## Product Change Notification

### PCN-PCC-7654-2022

Business Unit	Product Line Code	Type of Change	Action	Date of Issue
PCC - PCB Connectors	AAA	Product Change Notification	Notify Distributors and Field	1/25/2022

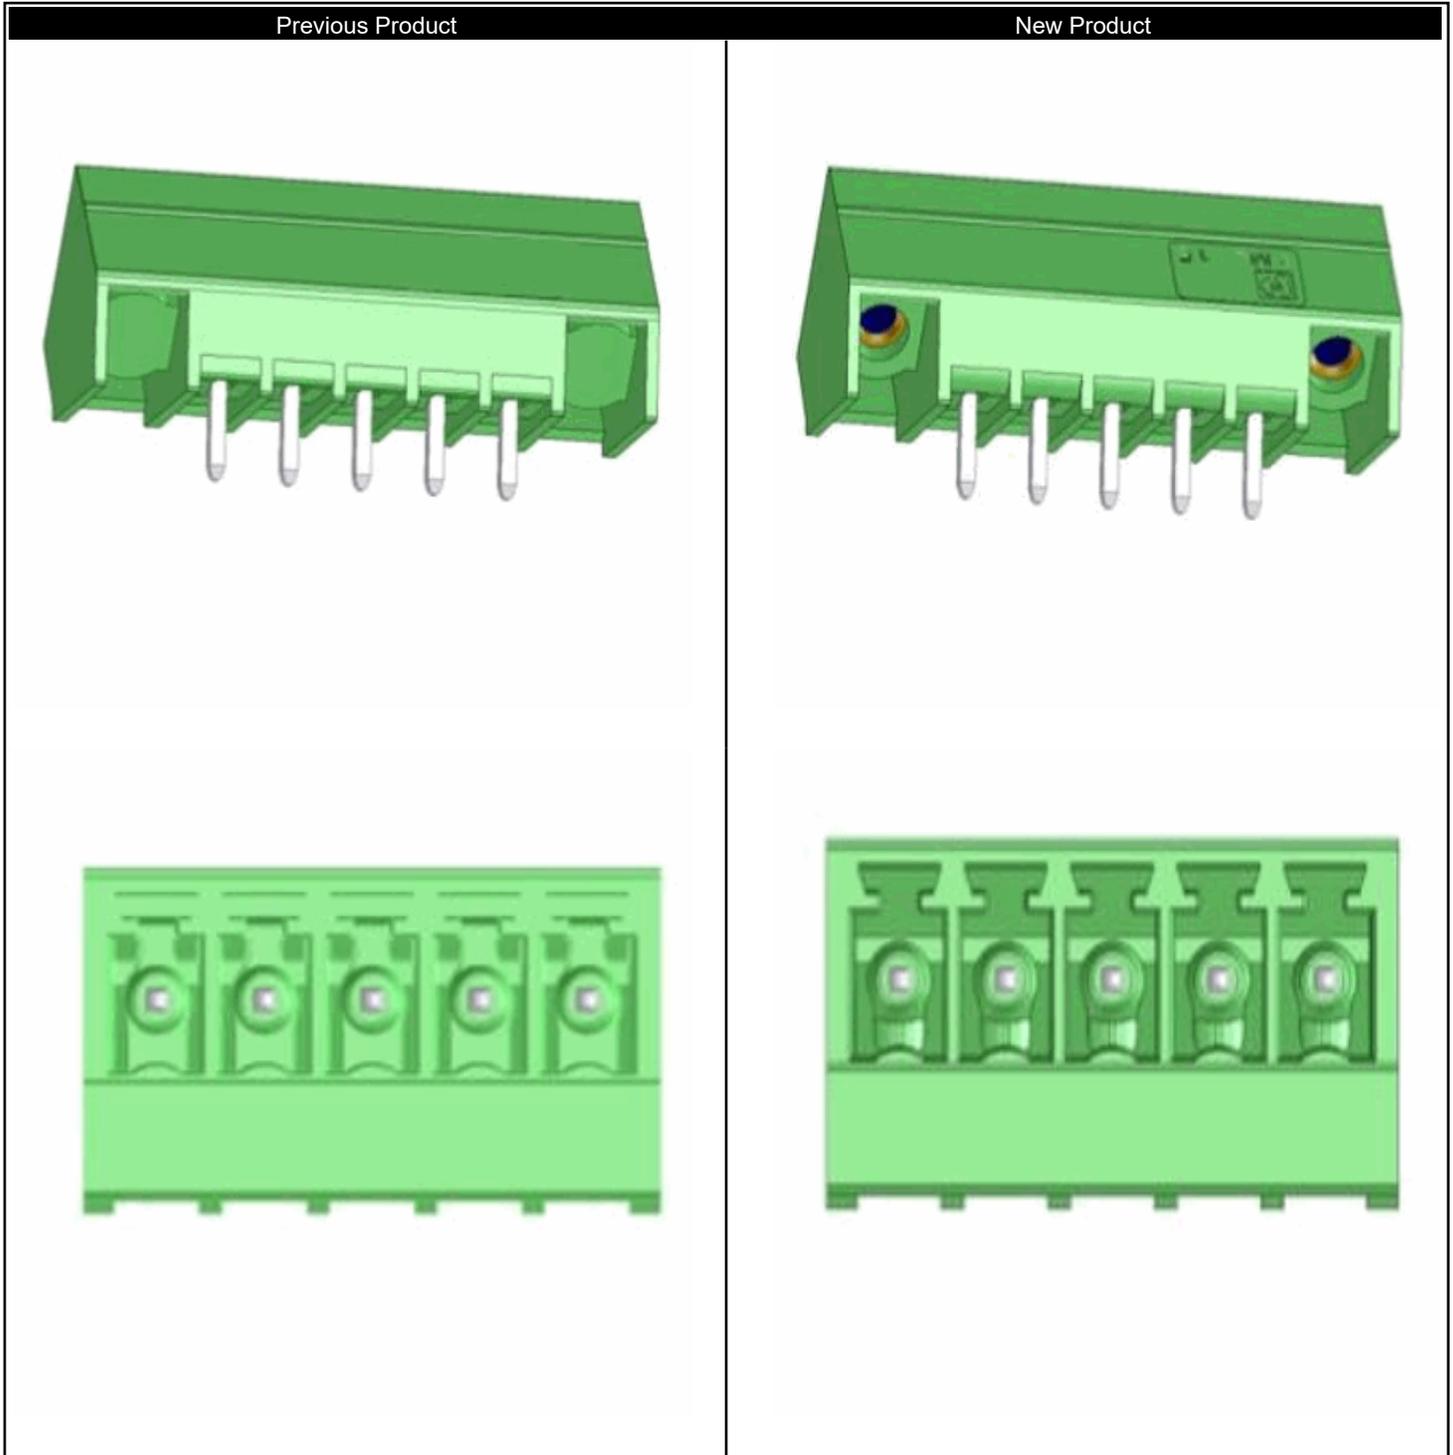
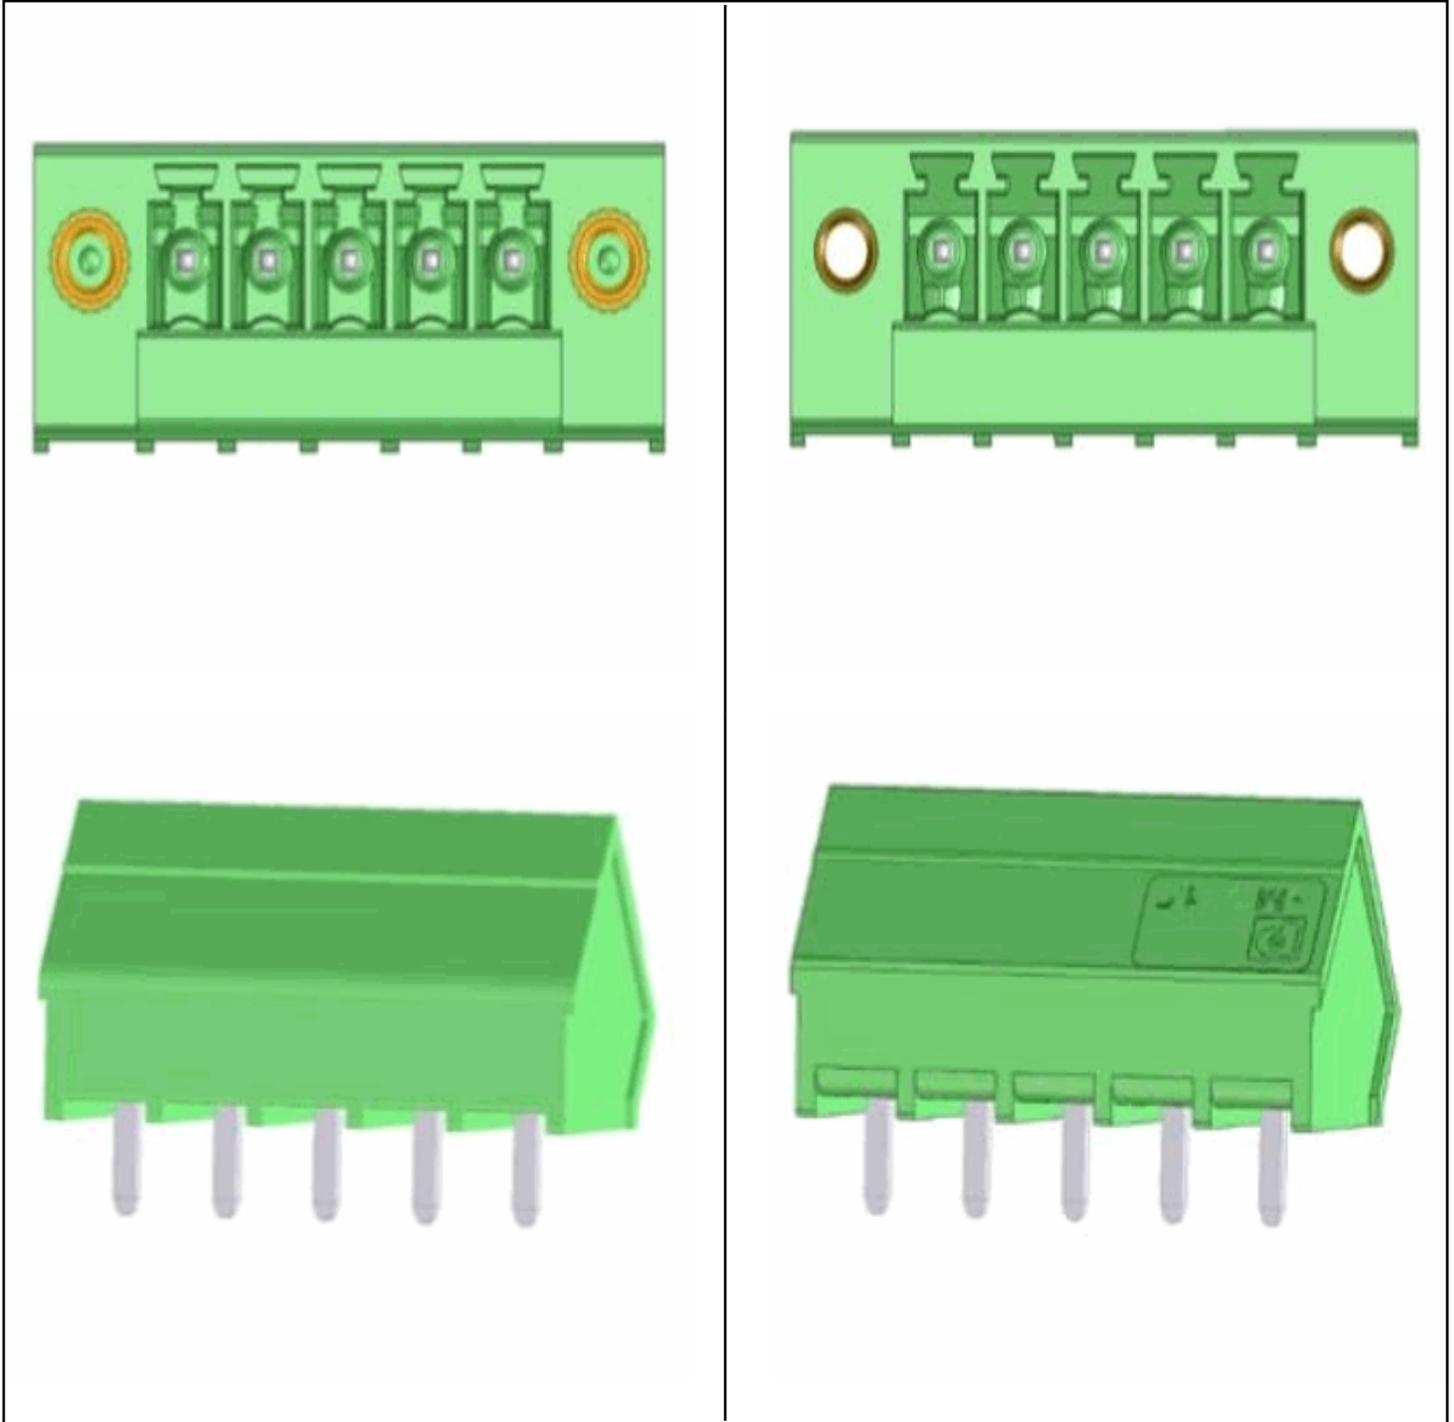
As part of ongoing improvement processes, the contour of the housing is being optimized in the pin connector pattern and the marking fields are being updated. In addition, there will be some changes to the shape at the back of the housing and around the screw flanges. The external dimensions, PCB layout, approvals, and technical data remain unchanged.
